**PEER REVIEW OF THE PROPOSED MINIMUM FLOWS AND LEVELS
FOR THE LOWER SANTA FE AND ICHETUCKNEE RIVERS AND
ASSOCIATED PRIORITY SPRINGS**

**Final Panel Report
October 11, 2013**

Figure 1: Cumulative rainfall from 1931 to 1970 for Lake City (LC), Gainesville (GNV) and the average of the Lake City and Gainesville (LC-GNV ave) rain gages.

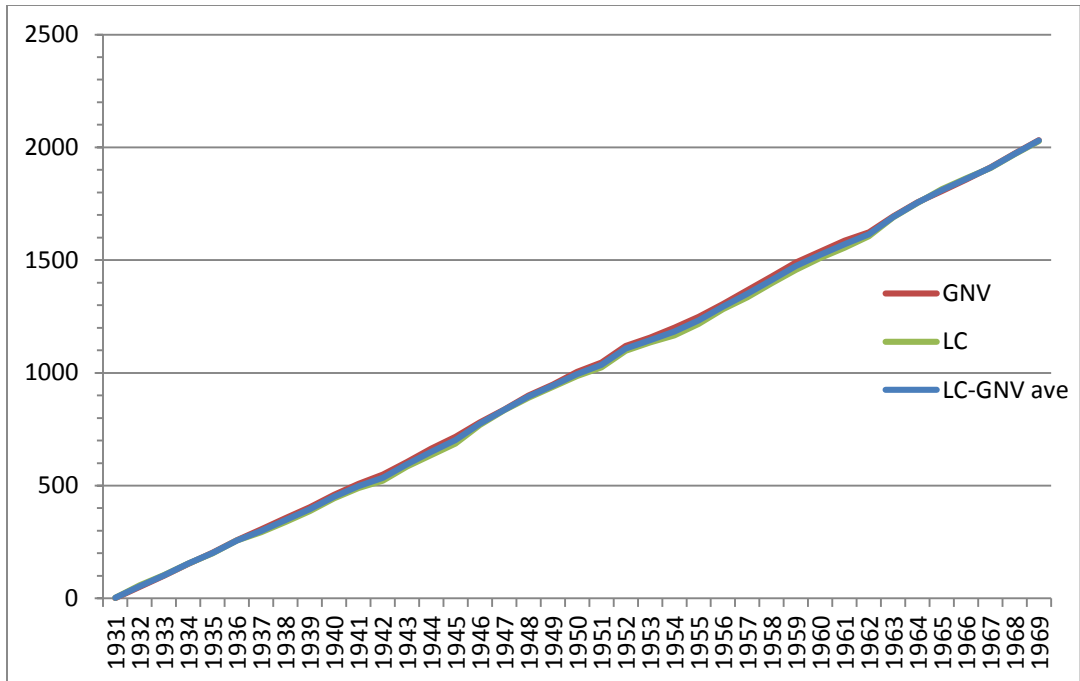
Rainfall records used to estimate the baseline flow regime used to set the minimum flow criteria originated at two primary gaging stations, including Gainesville and Lake City. Use of the two records was justified in part by stating that the two records better represent “spatial variability” of the rainfall (p. 2-13), but subsequently, the two records were averaged and the single record was used in the statistical analysis. Figure 1 shows cumulative rainfall for the Lake City, Gainesville, and the average of the Lake City and Gainesville stations from 1931-1970. Figure 2 shows the cumulative rainfall for the Lake City, Gainesville, and High Springs stations from 1970-2000 (note High Springs data is available from 1945 to present and this gage is directly within the lower Santa Fe River basin). These figures indicate that the data from the Gainesville and Lake City gages were similar to each other in the pre-1970 period for which the baseline model was developed. Similarly the Lake City and High Springs data are similar for 1970-2000, regardless of whether the missing High Springs data were filled from Lake City (HS -999=LC) or Gainesville (HS -999=GNV). However the Gainesville gage apparently received significantly less rainfall than the Lake City and High Springs gages in the 1970-2000 period, accumulating a 200 in deficit over the 40 year period. This rather large difference should be checked against other rainfall stations in the region that have data records for the 1970-2000 period (e.g. Live Oak, Suwannee County, 1898-2013; Mayo, Lafayette County, 1949-2013; Usher Tower, Levy County, 1956-2013) to determine if difference is due to the gages straddling a climate divide line (see e.g. Kelly, 2004 and Section IV.1.b.i below) or if the Gainesville gage is an anomaly in the region. Since spatial variability of the rainfall is apparently substantial, an analysis should be conducted to demonstrate the sensitivity of the baseline model parameters, predictions and residuals to the rainfall data used to develop them (e.g. Lake City, Gainesville, average of Lake City and Gainesville, or other stations). In particular, the use of the Lake City rainfall alone for the Ichetucknee baseline model should be considered since the Lake City gage is within the springshed and the Gainesville gage is much further away.

- Conduct an analysis to evaluate the sensitivity of the baseline model parameters, predictions and residuals to the rainfall data used to develop them (e.g. Lake City, Gainesville, average of Lake City and Gainesville, or other stations in the region with long-term data). In particular, consider the use of the Lake City rainfall alone for the Ichetucknee baseline model. Include an analysis of the High Springs rainfall and other relevant rainfall data from the region in the discussion of historical rainfall conditions.

Figure 3. Monthly values for the unsmoothed Atlantic Multidecadal Oscillation (AMO) index. Bold black line represents 12-month moving average. (from <http://www.cdc.noaa.gov/Correlation/amon.us.long.data>)

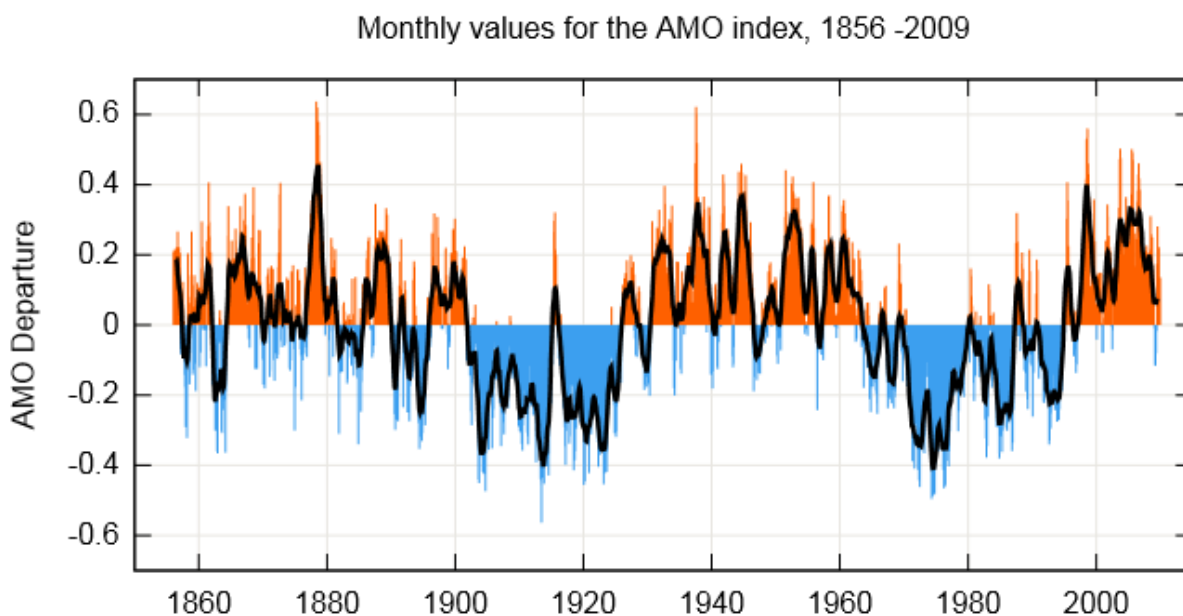
(Figure 59 Appendix 2-1), the 2-year moving average of the average of the Lake City and Gainesville rainfall data (Figure 4-6 main report), Ichetucknee baseflow (Figure 4-6 main report) and Ft White baseflow (Figure 70 Appendix 2-1) all show a tendency to increase from 1930 until about 1960-1970 and to decrease thereafter. The 1960-1970 period corresponds to the transition of the Atlantic Decadal Oscillation (AMO) from a warm phase to a cool phase (see Figure 3 below). Enfield et al. (2001) and Kelly (2004) have previously established that warm AMO periods lead to increased rainfall and streamflow, in South Florida, while the reverse is true in North Florida and much of the SE USA. Kelly (2004) showed that the Santa Fe Basin lies in a transition region where summer streamflow behavior tends to follow the South Florida pattern, while winter streamflow behavior tends to follow the North Florida pattern.

A major assumption made in the development of the baseline flow time series for the MFL analyses was that the timing of this climate transition between warm and cool AMO also corresponds to the time when anthropogenic activities (primarily groundwater pumping) began to have an effect on baseflows in the Ichetucknee and Lower Santa Fe Rivers. This assumption was based on the apparent similarity of the upward slopes of the rainfall and baseflow LOWESS curves in the pre-1970 period, and the apparent steeper downward slopes of the baseflow curves compared to the rainfall curve in the post-1970 period (Figure 4-6 main report and Figure 70 Appendix 2-1). Although it is asserted that there is a “stark” difference in the post-1970 rainfall and streamflow slopes (p4-10), no statistical tests of the significance of the differences in slopes were conducted, nor is it clear *a priori* why they should have the same slope given likely non-linearities present in the flow generation process.

Figure 4: Average monthly rainfall, evapotranspiration, and rainfall- evapotranspiration for 2000-2008 in the Santa Fe Basin (Srivastava, 2013)

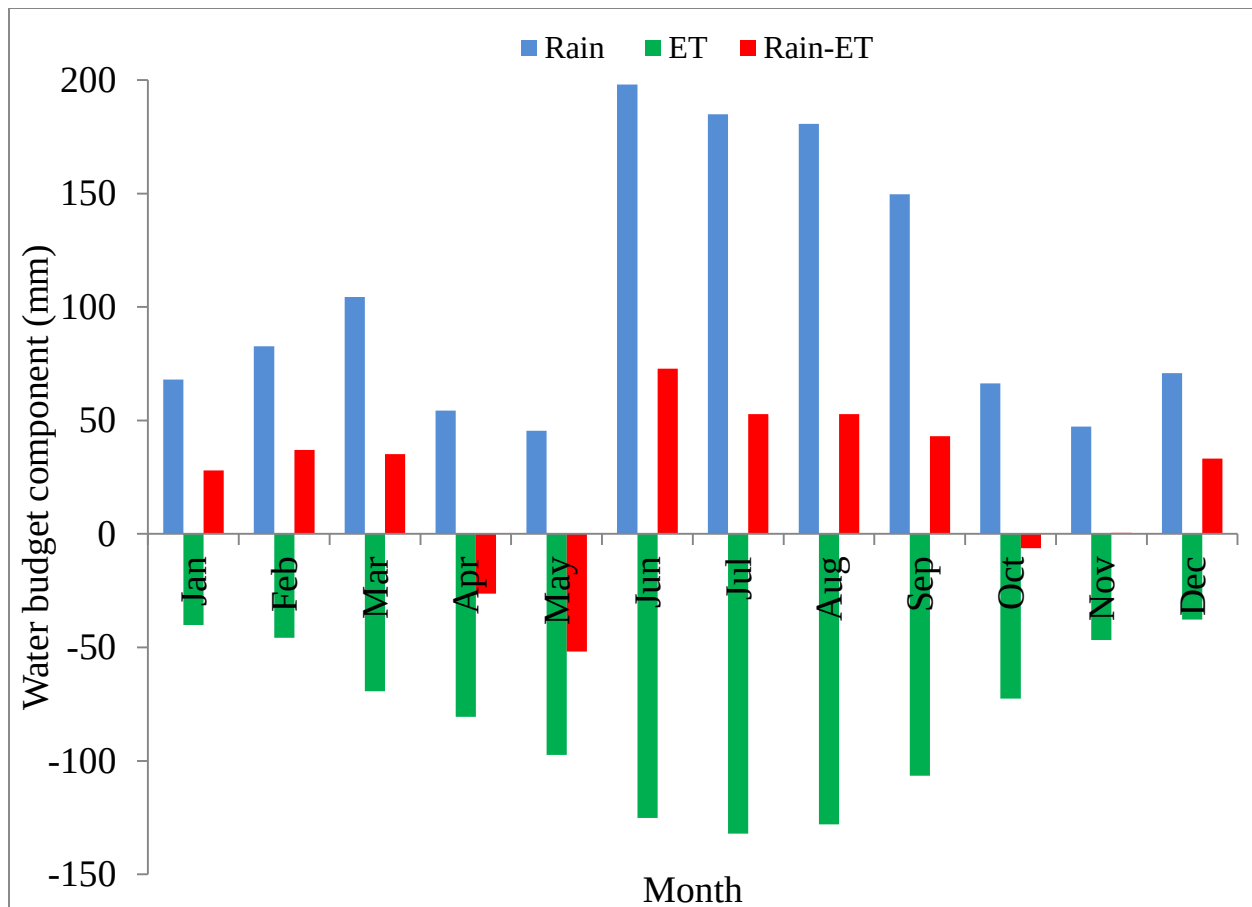
i) Baseline Model development. Because the baseline model developed in Chapter 4 of the MFL report does not incorporate the non-linear effects of antecedent moisture conditions, or any seasonal or interannual periodicity, the resulting residuals are large (-600 to +500 cfs; Figure 72 in Appendix 2 and Figure 5 below) with extremely high temporal autocorrelation (Figure 6 below). Moreover the baseline model systematically over-predicts low flows and under-predicts high flows (Figure 7 below). These residual behaviors are well accepted indicators of inadequacies in model structure: a well-fit model will generally have residuals that show no systematic bias, have low standard deviation compared to the original time series, and minimize temporal autocorrelation (i.e., approach white noise).

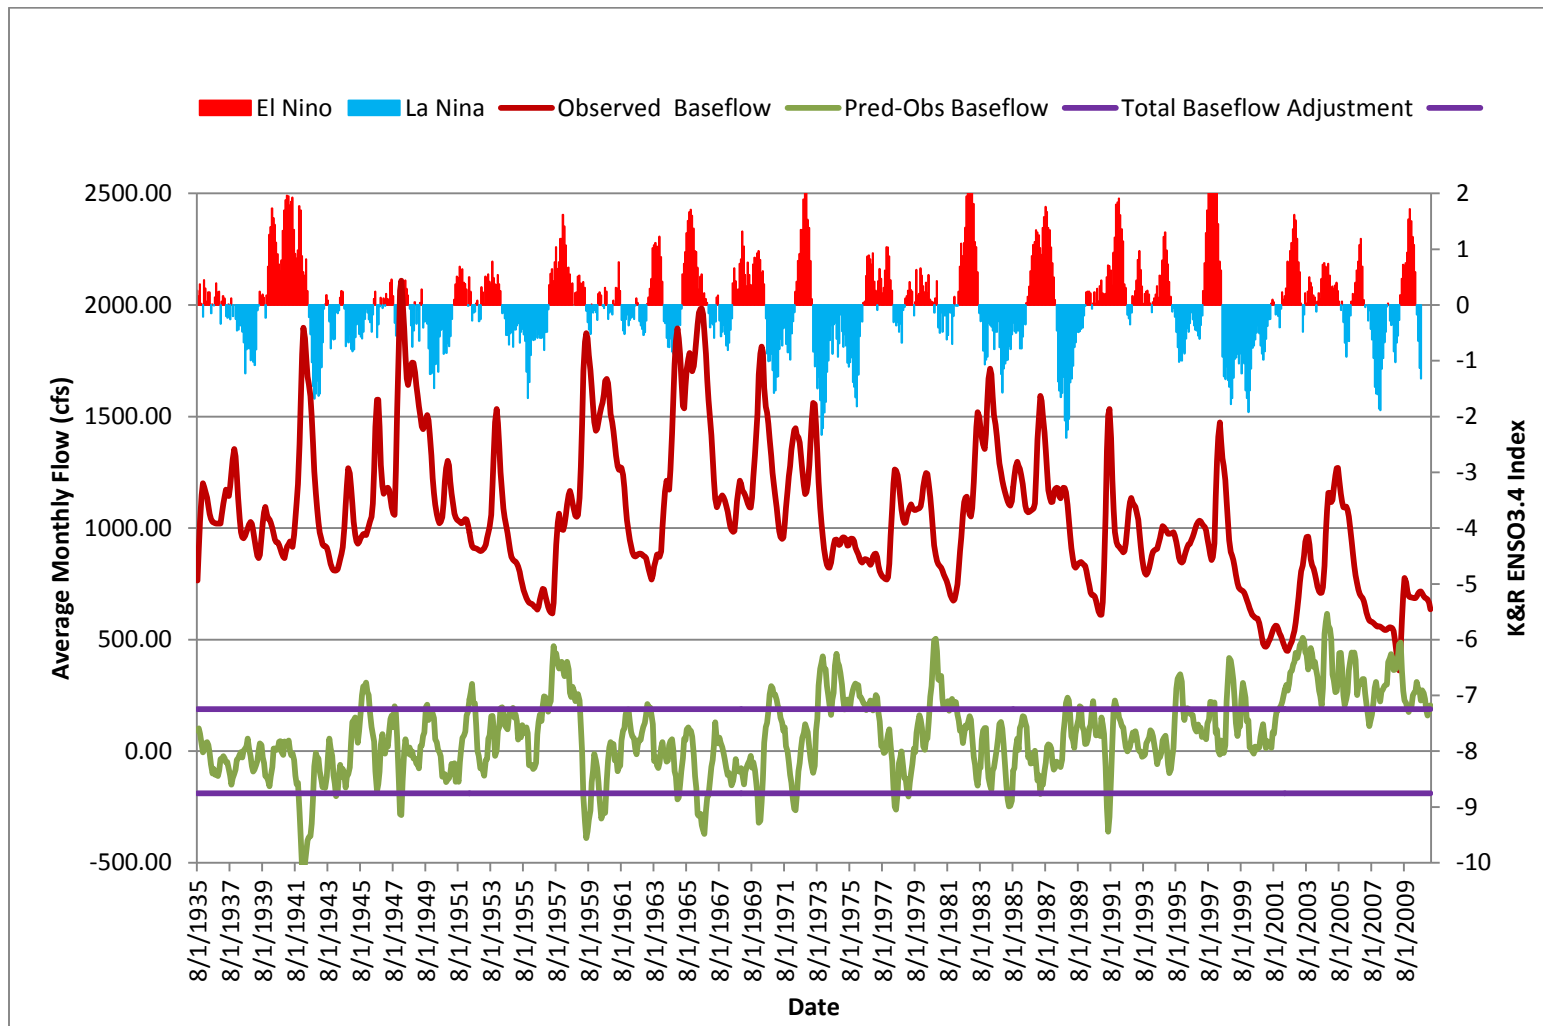
Figure 5 indicates that peak observed baseflows and large negative MLR baseflow residuals generally follow strong El Nino periods, and minimum baseflows and large positive residuals generally follow strong La Nina periods. This behavior is an indication that the 6-7 year periodicity shown in Figure 6 is a likely related to ENSO cycle effects. This figure also shows that MLR baseflow residuals appear to vary fairly regularly around zero from 1935-2000, then appear to increase abruptly beginning in 2001 and remain high for the duration of the study period. That is, they do not show a persistent linear increase beginning in 1970, but may show a step change occurring in about 2000. Enfield et al. (2001) showed that in North Florida, and throughout most of the SE USA, winter rainfall during El Nino events tends to be lower during warm AMO periods. Thus the transition of the AMO from cool to warm phase in approximately 1995 may contribute to the lower baseflows and higher residuals observed in the 1999-2010 period. Figure 8 shows the temporal autocorrelation structure of the various multidecadal (AMO), interannual (ENSO), and seasonal climate cycles that affect streamflow at station 2500 on the Santa Fe River and underscores the strong, complex, cyclical climate signals that affect streamflow in the Santa Fe Basin.

Figure 7: Magnitude of MLR residuals as a function of baseflow. Low flows are systematically over predicted and high flows are systematically under predicted for both the pre and post-1970 periods

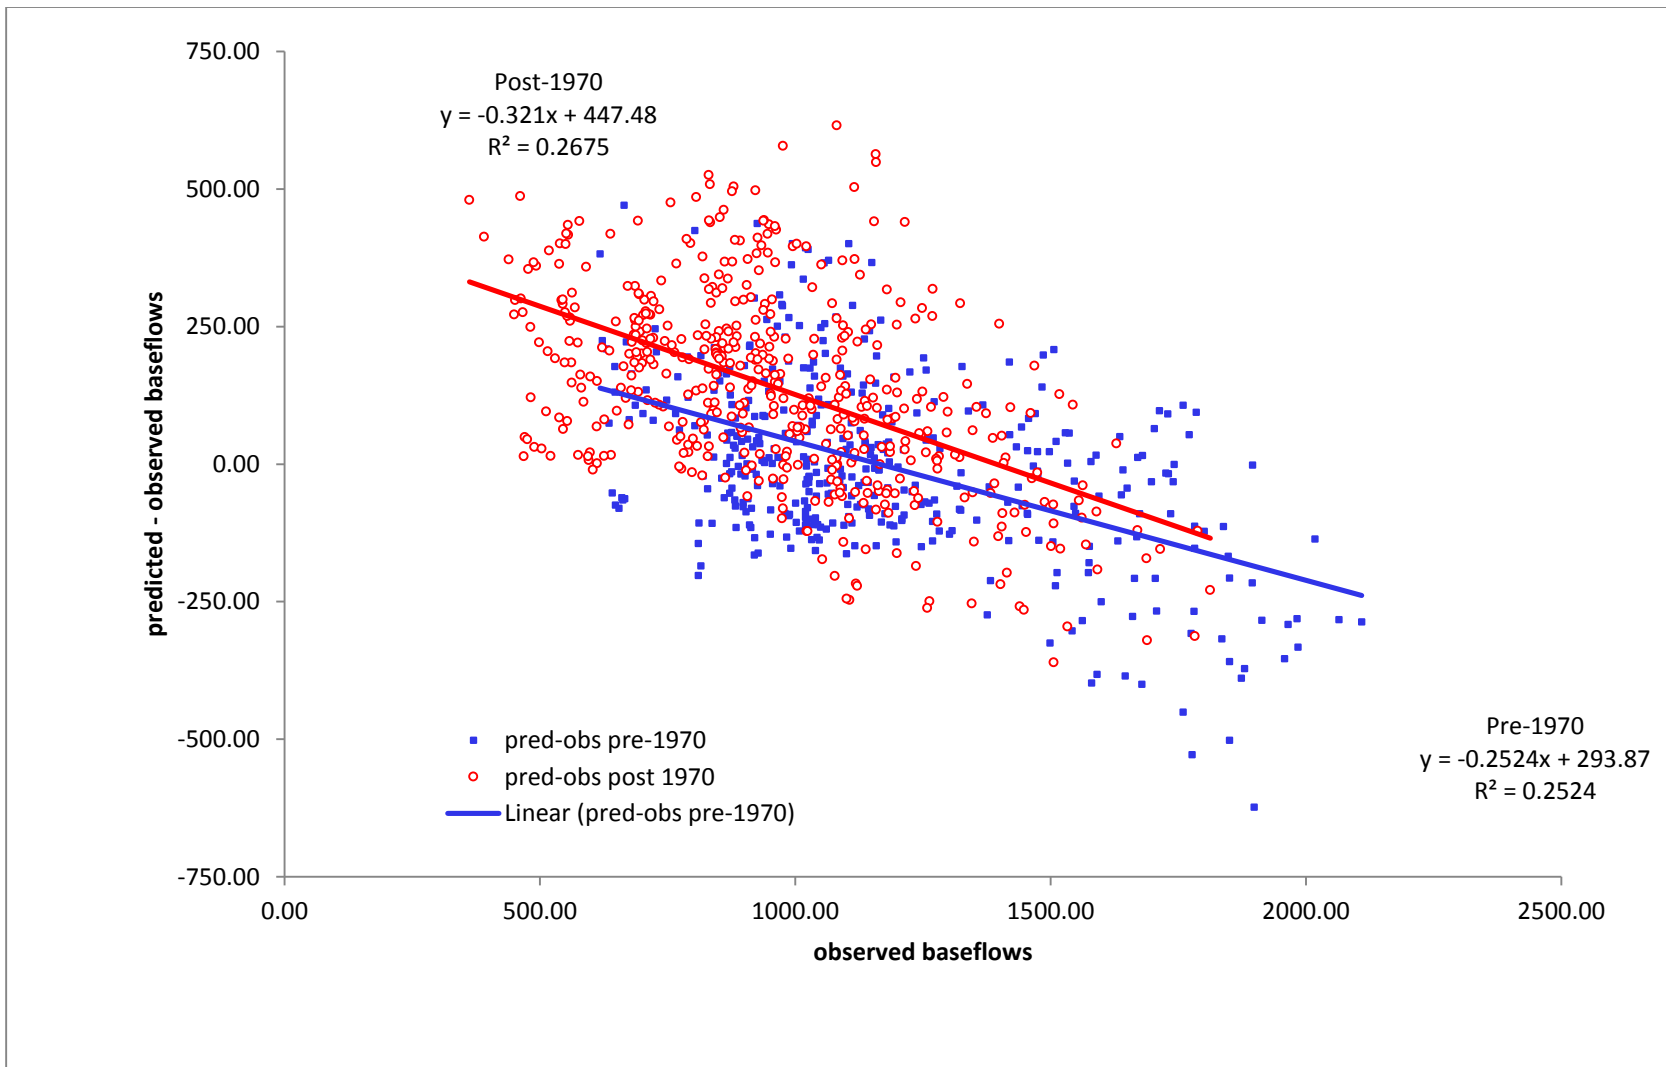
The tendency for the baseline model to over-predict low flows (Figure 7) is particularly significant because ~1999-2010 was a persistent dry period, exhibiting drier conditions than occurred at any time during the pre-1970 model calibration period (Figure 5). Furthermore this time period exerts high leverage on the estimated linear trend in the post-1970 MLR residuals which provides the basis for adjustment of the historic baseflow time series for the effects of groundwater pumping. Table 2 presents the linear regression parameters and statistics for the MLR residual time series over various time periods. Shaded rows in the table indicate time periods over which the slopes of the residuals are not significantly different than zero. While the p-values and confidence intervals must be interpreted with caution given the non-white noise structure of the residual time series, conventional test statistics indicate that if the series is broken up into 1935-1970, 1970-2000, and 2000-2010 time periods, none of these periods have residuals with a statistically significant slope (although the 2000-2010 residuals appear to have a significantly different mean value). Furthermore the R^2 value for the linear fit of the post-1970 residuals (figure 73, Appendix 2-1) is only 0.153, indicating that a linear relationship does not explain much of the variation. *All of these factors indicate that it would be prudent to investigate alternative, non-linear baseline model structures and alternative assumptions about the onset and structure of anthropogenic impact.*

Figure 9: Flow Duration Curves for the Ft. White station complete data series, pre-1970 data, post-1970 data, baseline flow, and MFL flows. FDCs for the complete data series and the pre-1970 data series meet the MFL. FDC for the post-1970 data series violates the MFL at flows above ~ 1250 cfs.

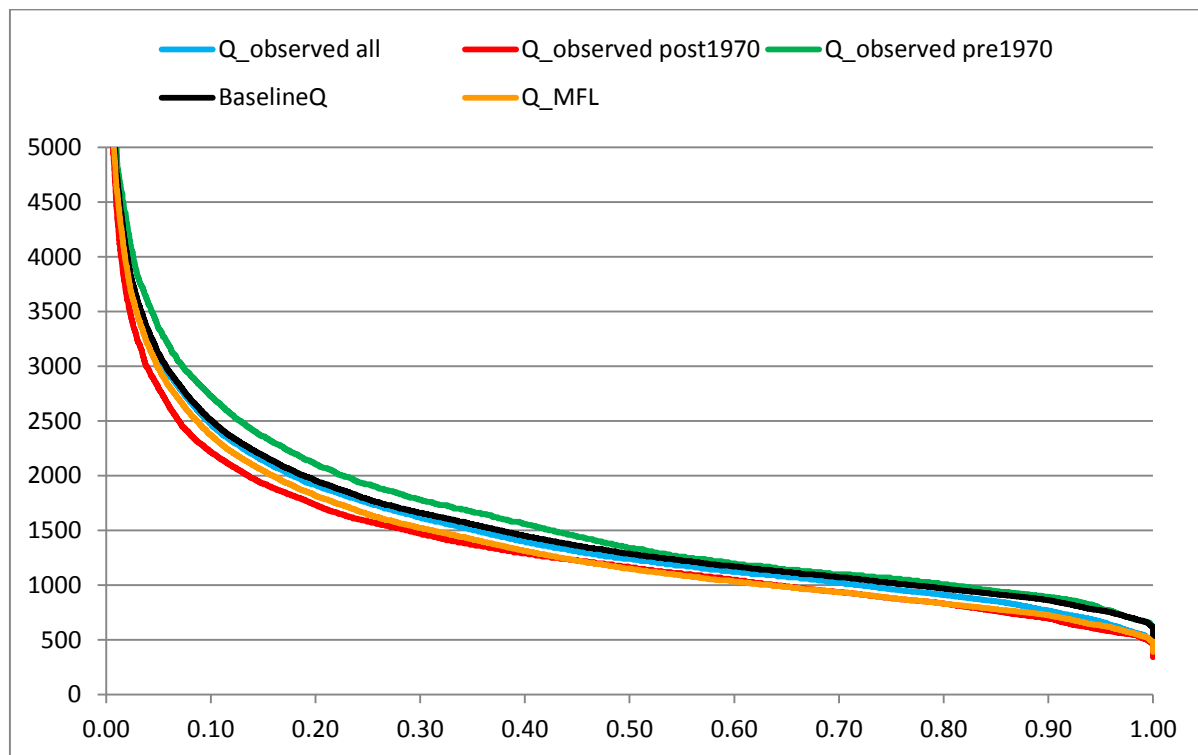
i) The procedure used to determine the current status of the water body in relation to the MFL. To determine the current regulatory status of the Lower Santa Fe and Ichetucknee Rivers, an MFL flow regime was produced by subtracting the allowed MFL flow reduction from the predicted baseline flow over the entire period of record. Next the annual means of the observed and MFL flow regimes were computed, and the difference between the observed and the MFL annual mean values at the end of the period of record values were computed. If the difference at the end of record was positive (as for the Ichetucknee) it was assumed that the waterbody was meeting the MFL and had additional water available. If the difference at the end of record was negative (as for the lower Santa Fe) it was assumed that the water body had a flow deficit and was in violation of the MFL. *This methodology puts more confidence than is warranted in the predictions of the baseline model given its shortcomings discussed above.*

Using FDCs to determine current status is also untenable because changes in the FDCs can be detected only over time scales too long to be of regulatory relevance. Figure 9 shows FDCs for the observed 1935-2010 time series, the baseline 1935-2010 time series, the MFL 1935-2010 time series, the 1933-1970 observed time series and the 1970-2010 observed time series. This figure indicates that FDCs for the complete observed data series and the pre-1970 observed data series meet the MFL, but that the FDC post-1970 violates the MFL at flows above approximately 1250 cfs. We note also that all FDCs meet the MFL at median flow, which is presumably the condition simulated by existing steady state groundwater models. The fact that post-1970 data meet the MFL at low and median flows but not high flows is counter-intuitive to the expectation that the most critical periods for the rivers will be during drought periods when antecedent recharge is low and demand for groundwater is high. *The methodology for determining the current status of the water body with regard to the MFL warrants additional consideration.*
